<i>NCSX RFD</i> <i>Part I</i>	Number: RFD-14-013	RFD Description: Change to C-4 through C-6 Flange Seats from a Spherical Seat to a Counterbore Seat
Initiator: Kevin Bowling and Phil Heitzenroeder		Organization: Major Tool/PPPL
List of Impacted Documents: (<i>Specification, MIT/QA Plan, SOW, drawing, etc.</i>) Drawing SE141-116		
Cost Impact: (<i>If none, so state</i>): <i>None realizable; the primary motivation for this change is to save machining and inspection time.</i>		
Schedule Impact: (<i>If none, so state</i>): <i>Machining and inspecting a counterbore is much easier to perform than a spherical seat. This is expected to save several hours of machining and inspection time and expected to avoid non conformance conditions – it was not possible to achieve the tolerances required for the spherical seats on C1 and C2. These were accepted “as is” but will require time –consuming lapping at PPPL to rectify.</i>

<i>NCSX RFD</i> <i>Part III</i>	Number: 14-013	RFD Description: Change to C-4 through C-6 Flange Seats from a Spherical Seat to a Counterbore Seat
RLM: Brad Nelson/Wayne Reiersen for BEN		Organization: PPPL
Impact on Interfaces with Other WBS Elements/Items: <i>(If none, so

C-4 Counterbore Seat (Typical) Detail Sketch

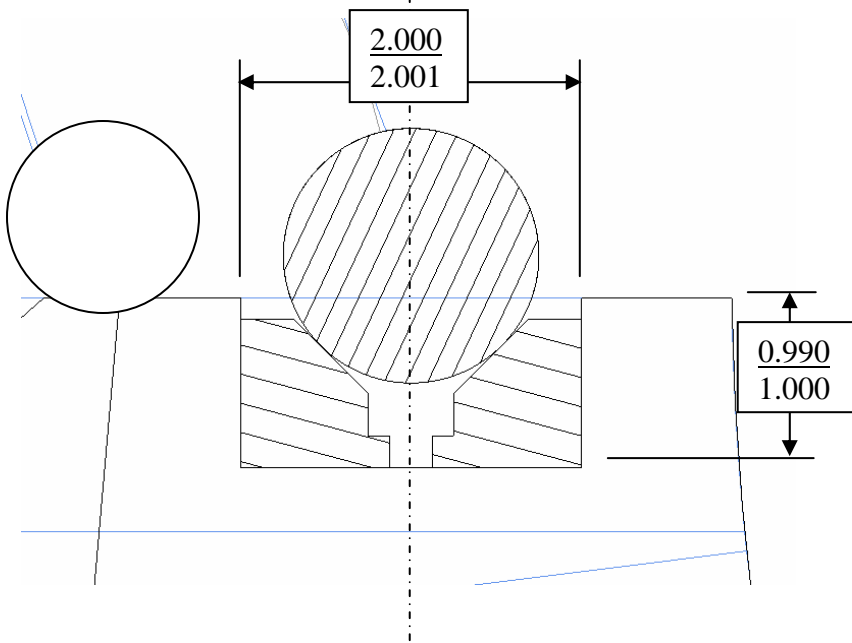
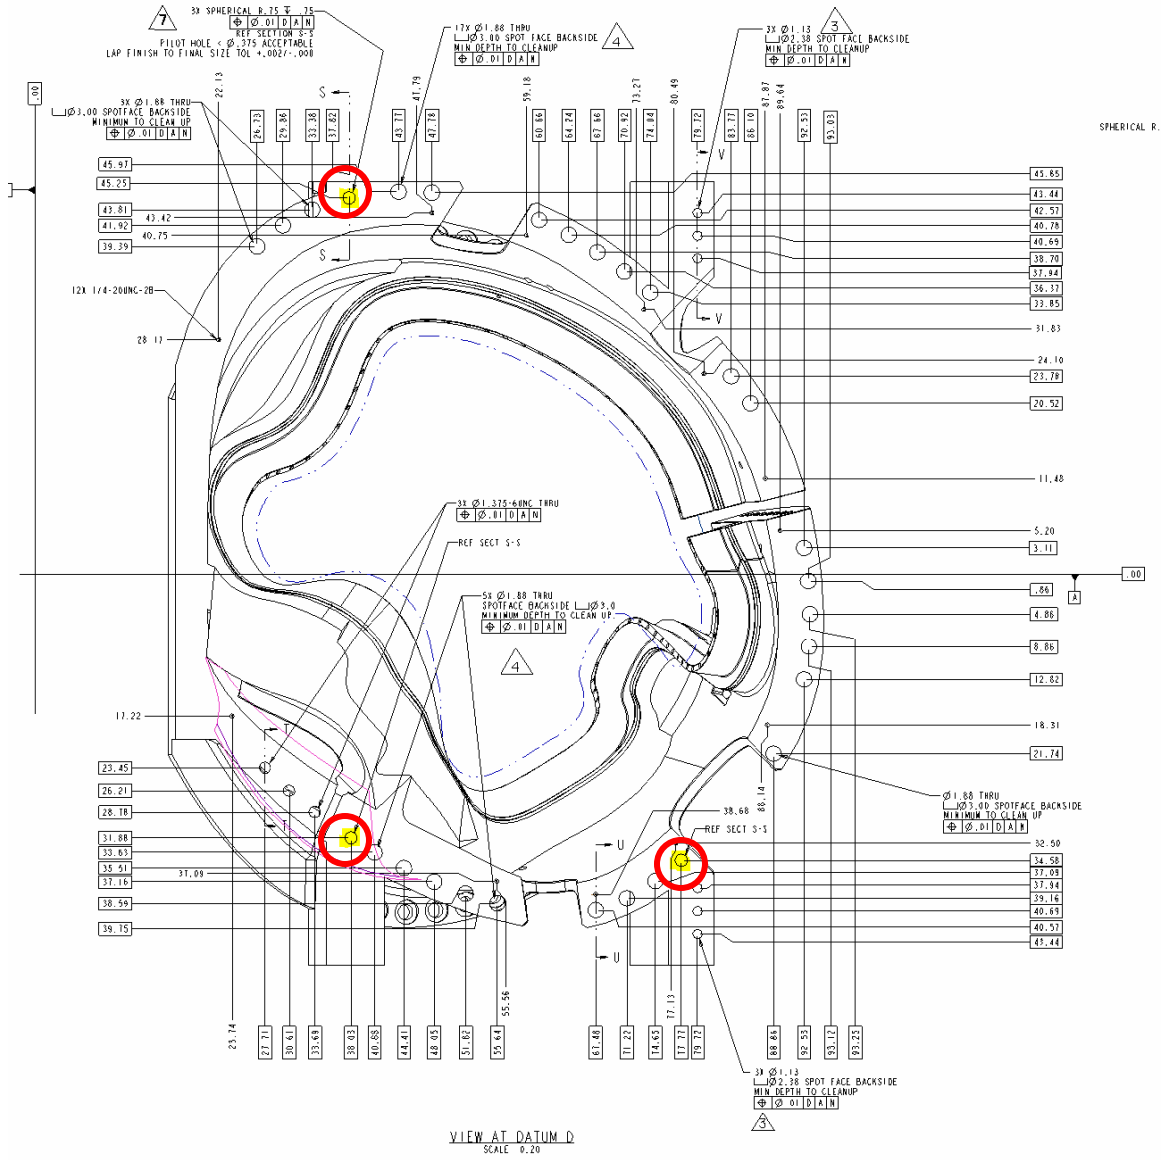
Quality Impact: (<i>If none, so state</i>): <i>Whereas it was not possible to achieve conforming tolerances on C1 and C2 with spherical seats, tolerance conformance is expected with the counterbores.</i>		
State Requirement Deviation is Requested For: (<i>Specification, MIT/QA Plan, SOW, drawing, etc.</i>): Drawing SE141-116		
Full Description of the Deviation Requested: (<i>Use continuation pages, e-mails, letter, sketches, etc. as needed and include amplifying information as appropriate to support deviation request.</i>): During technical meetings at MTM the week of January 3 rd , MTM identified difficulties encountered machining and inspecting the spherical seats on the flanges. MTM requested that consideration be given to changing the spherical seats to conical seats, starting with the C-3 casting and for all follow-on castings. Subsequently, counterbores were suggested as a replacement for the conical seats so that custom “pucks” could be inserted with an appropriate configuration (eg, conical seat, conical groove, flat) The counterbored seats should be easier to machine and inspect. See the attached figure “C3 Counterbore Seat Detail Sketch”.

RLM Signature: _____		
<p>Project Disposition:</p> <p><input type="checkbox"/> Approved. No ECP required.</p> <p><input checked="" type="checkbox"/> Approved. ECP -042 being processed to pickup this change.</p> <p style="text-align: right;">_____ NCSX Systems Engineering Support Manager</p> <p><input type="checkbox"/> Not Approved. Reason(s) for disapproval:</p>
